Re: Application No. Z-61
Applicant and Property Owner: EMAE, LLC
Property: 384 & 385 of the 18th District,
Located on the west side of Factory
Shoals Road, 199.74 feet south of
West Starling Drive.

EMAE, LLC / FACTORY SHOALS, LLC
PRELIMINARY PLAT FOR
18th DISTRICT - East SECTION
DEPT. 02-11-19
PROPOSED LOTS: 1-10
PIN: 18083060480
188,654 ± SQ. FT.
2.885 ACRES

PETITION NO: Z-47
HEARING DATE (PC): 6-04-02
HEARING DATE (BOC): 6-18-02
PRESENT ZONING: R-20
PROPOSED ZONING: RA-5

| Rezoning Plat for Van Conner | |

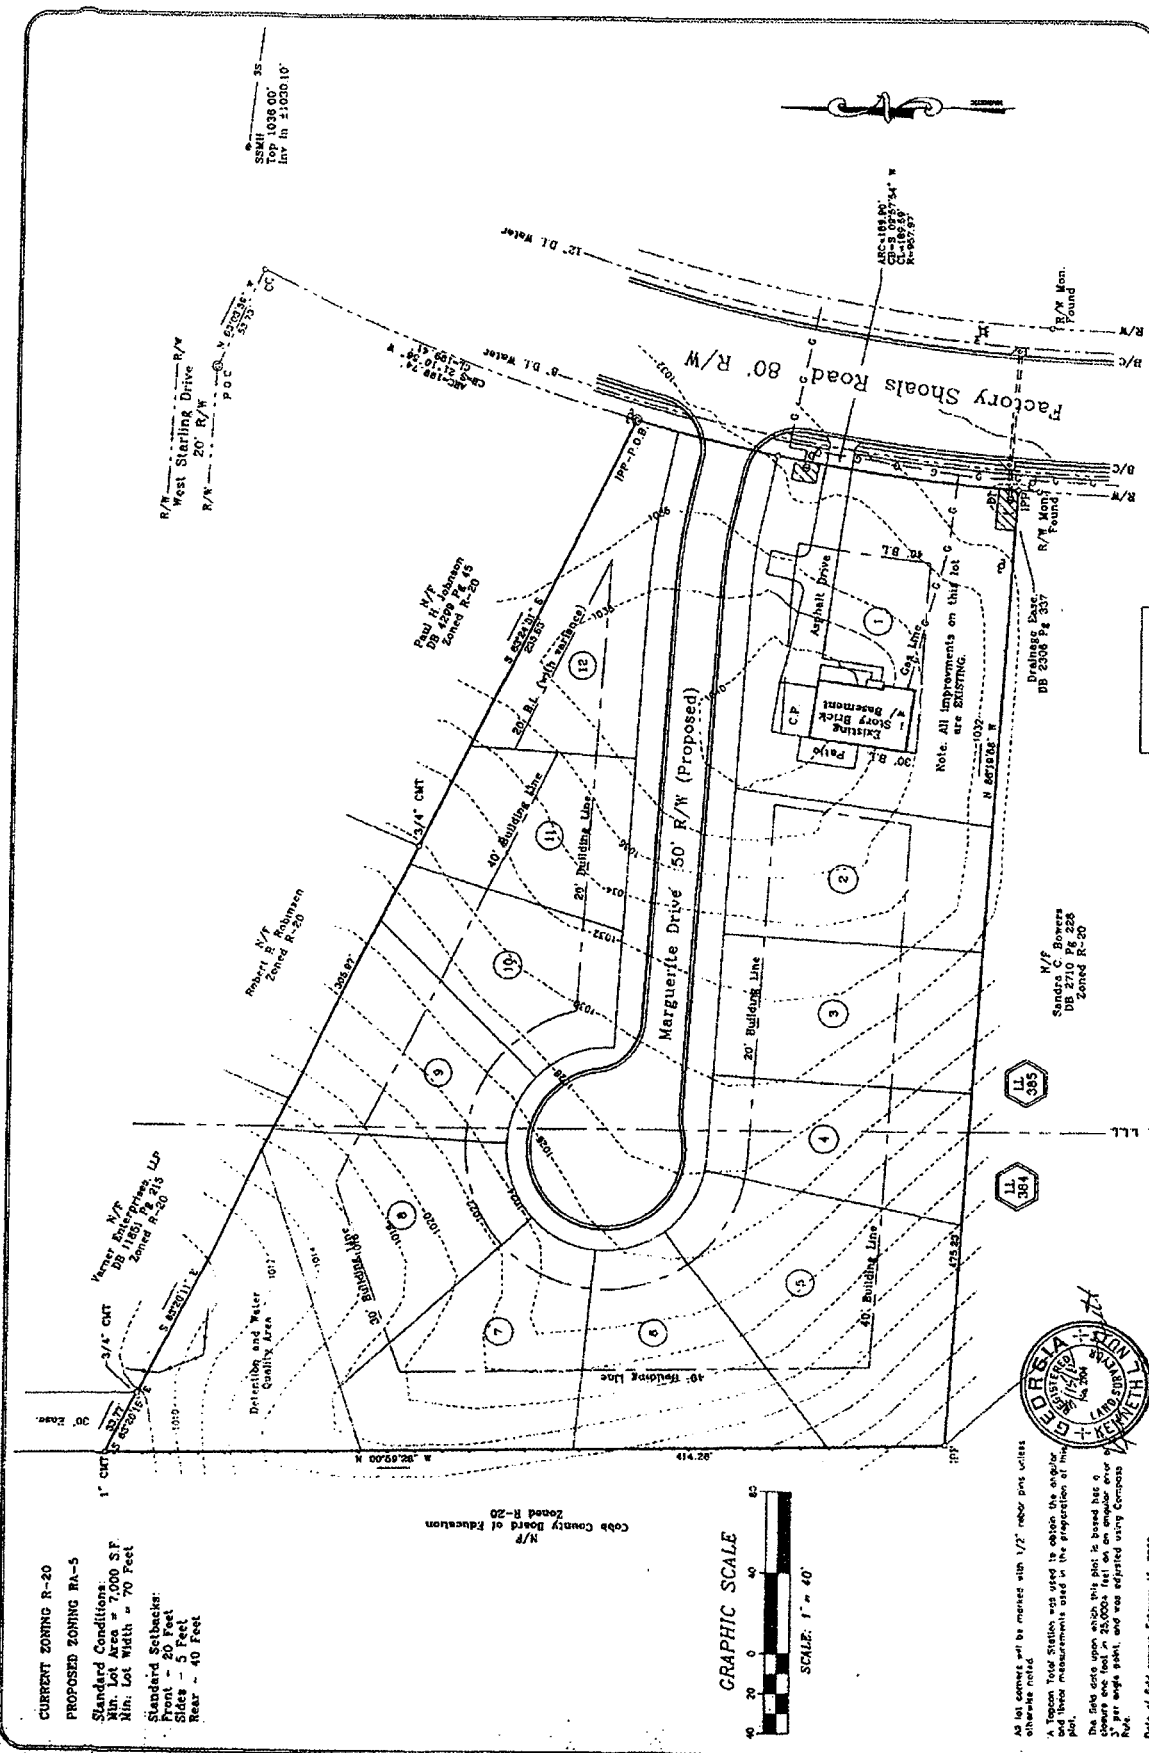
- No Stormwater controls shown see comments below
- Copy of survey is not current - Additional comments may be forthcoming when current site conditions are exposed.
- No site improvements showing on exhibit.

- The tract is cut by 3 ridges such that (A) the entrance and 75% of lot 12 flow Northeast away from detention; (B) majority of lots 1-6 plus 50% of lot 7 flow Southwest away from detention; (C) majority of road and lots 8-11 plus remainder of lots 7 & 12 are directed to detention. Terrain will require extensive grading to transfer runoff from bypass areas to detention. Transfer will be limited by Code/Law and ability of downstream system to handle flow.
- Hydrology of subdivision must recognize improvements on lot 1 as new and provide flow mitigation and water quality accordingly.
- To comply with County Ordinance, grading for development and builders must be limited to roadway and building pad. Remainder of lot area must be left natural. Entire lot shall not be graded.

Resoning Plat for Van Conner

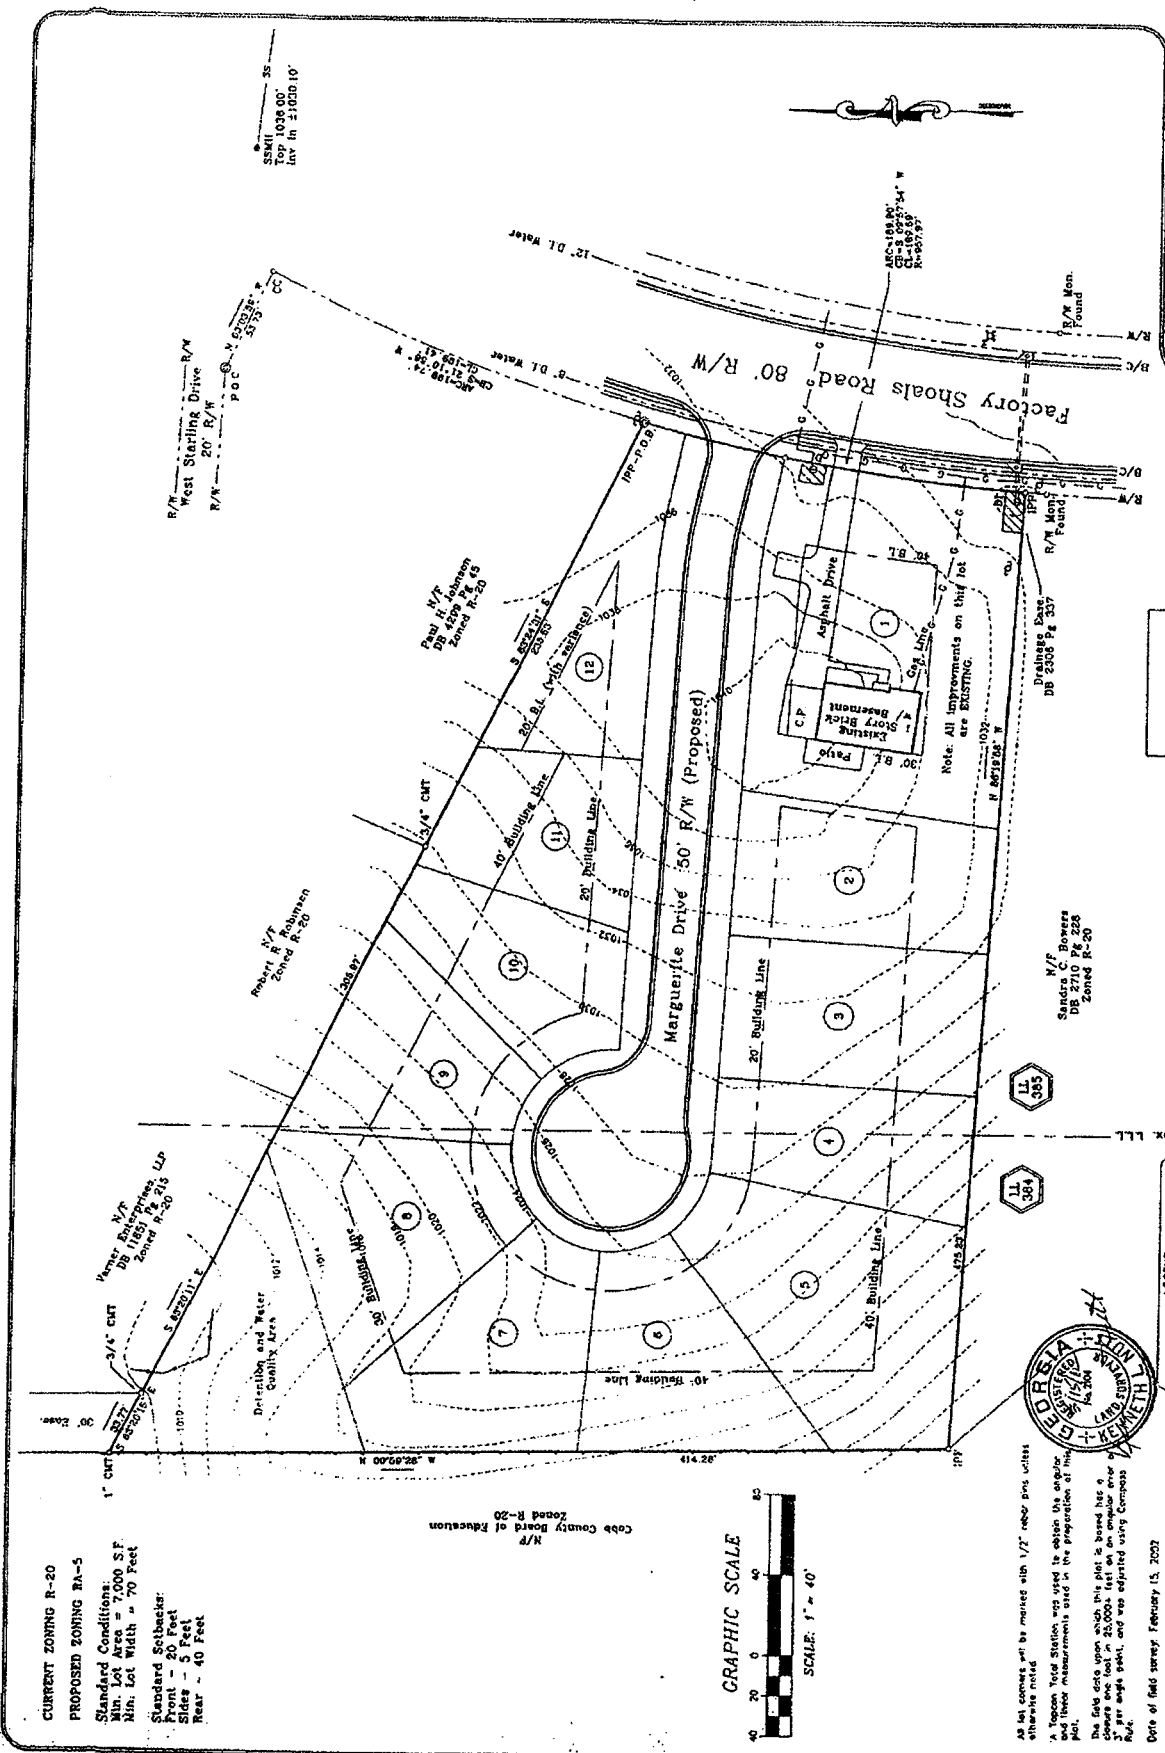
- No Stormwater controls shown see comments below
- Copy of survey is not current - Additional comments may be forthcoming when current site conditions are exposed.
- No site improvements showing on exhibit.

- The tract is cut by 3 ridges such that (A) the entrance and 75% of lot 12 flow Northeast away from detention; (B) majority of lots 1-6 plus 50% of lot 7 flow Southwest away from detention; (C) majority of road and lots 8-11 plus remainder of lots 7 & 12 are directed to detention. Terrain will require extensive grading to transfer runoff from bypass areas to detention. Transfer will be limited by Code/Law and ability of downstream system to handle flow.
- Hydrology of subdivision must recognize improvements on lot 1 as new and provide flow mitigation and water quality accordingly.
- To comply with County Ordinance, grading for development and builders must be limited to roadway and building pad. Remainder of lot area must be left natural. Entire lot shall not be graded.
